MAINE BUREAU PARKS AND PUBLIC LANDS (BPL)
Department of Agriculture, Conservation and Forestry
22 State House Station - Augusta, Maine 04333-0022

FINAL MEETING NOTES

**CROCKER MOUNTAIN UNIT MANAGEMENT PLAN
ADVISORY COMMITTEE (AC) MEETING**

Carrabassett Valley, Maine
February 25, 2015
6:00 – 7:30 PM

Crocker Mountain Unit - Dominant Use Allocations

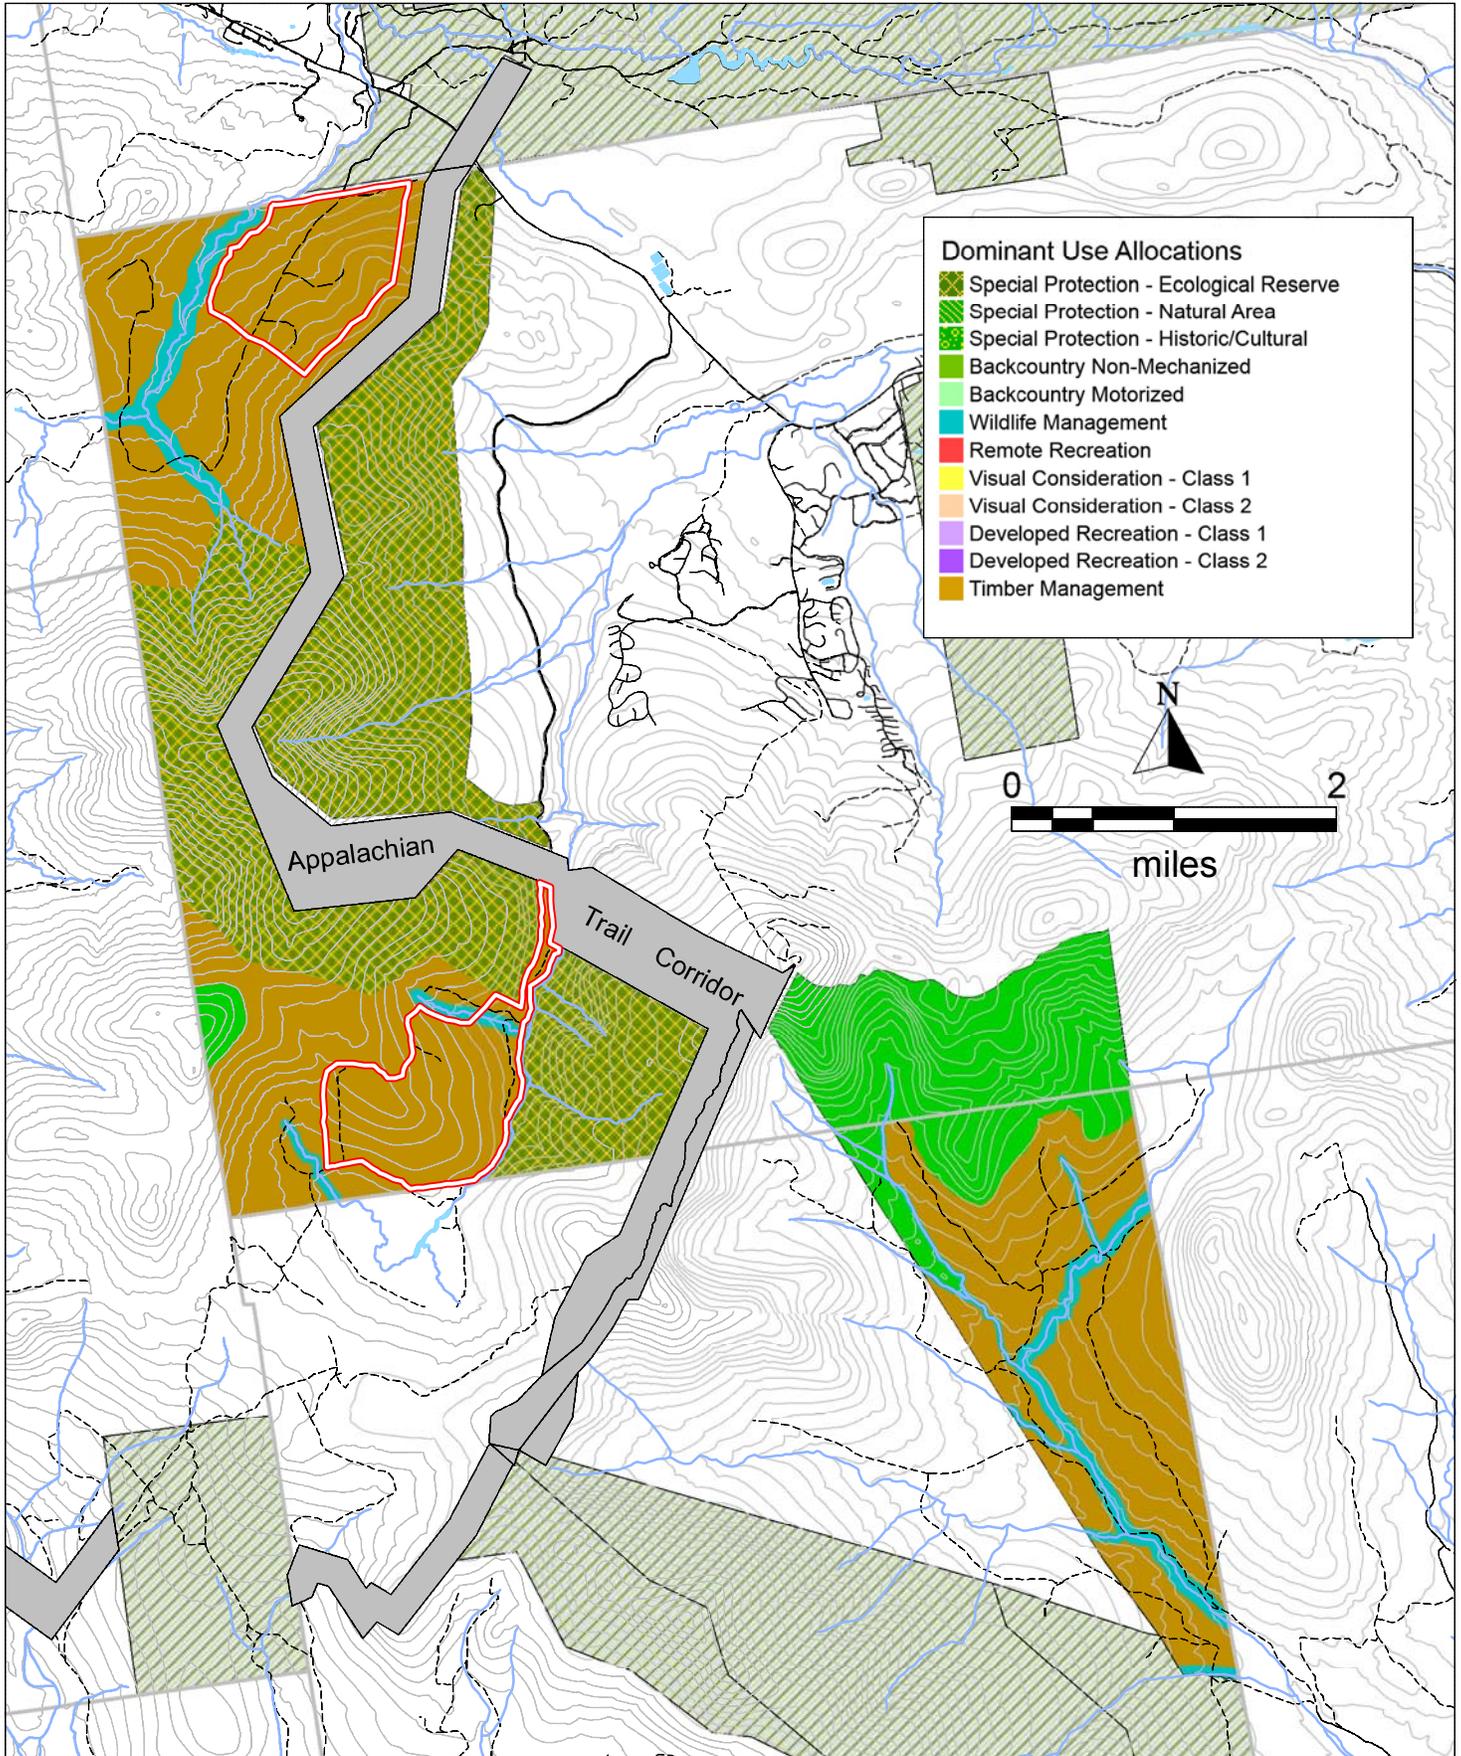
Special Protection Areas: Bob Luce expressed concern that the current designation of the entire parcel east of the Appalachian Trail Corridor as Special Protection - Ecological Reserve would not provide enough flexibility for potential future recreational uses, particularly motorized trails. The town does not want the Plan to block a potential north-south motorized (snowmobile, groomed cross-country skiing) trail connection from Route 27. There is the possibility that the current snowmobile access down Caribou Valley Road

(which Plum Creek allows on an annual basis by special permission) could be lost when the Plum Creek lands surrounding the road are developed, as permitted by current zoning. A suggestion was made that a 100 foot corridor along the east boundary of the Ecological Reserve be removed from the Special Protection - Ecological Reserve allocation to provide an option to Caribou Valley Road for routing a motorized trail in the event that the road becomes closed to ORVs. BPL commented that there was leeway available in the acreage allocated to Special Protection/Ecological Reserve in the Draft Plan that would allow for the suggested corridor, and a specific response to the request would be incorporated into the Final Draft Plan.

Mountain Bike Trails: The presentation highlighted two areas, encircled on the Dominant Allocation map with a red line, where future mountain bike trail development would be focused. Both areas have an underlying Timber Management dominant use allocation. In response to a question as to whether that allocation would allow for future trails to be protected from the impacts of timber harvesting, BPL explained that any trails would be allocated to Developed Recreation when built.

Include a "motorized trail corridor" approximately up to 1,000' wide along the eastern property line of the parcel that is on the western side of the Caribou Valley Road from Rt. 27 to the Appalachian Trail crossing on this road. We believe this corridor to be approximately four miles long which, at 1,000' wide, would include approximately 485 acres. If and when the trail ever got built the actual trail would probably only encompass approximately 5 acres at 20' wide (at four miles in length). However, due to the logistics of actually locating the trail on this parcel (topography, ledge, etc.) the trail would need to "move around" within this corridor to actually be feasible to build.
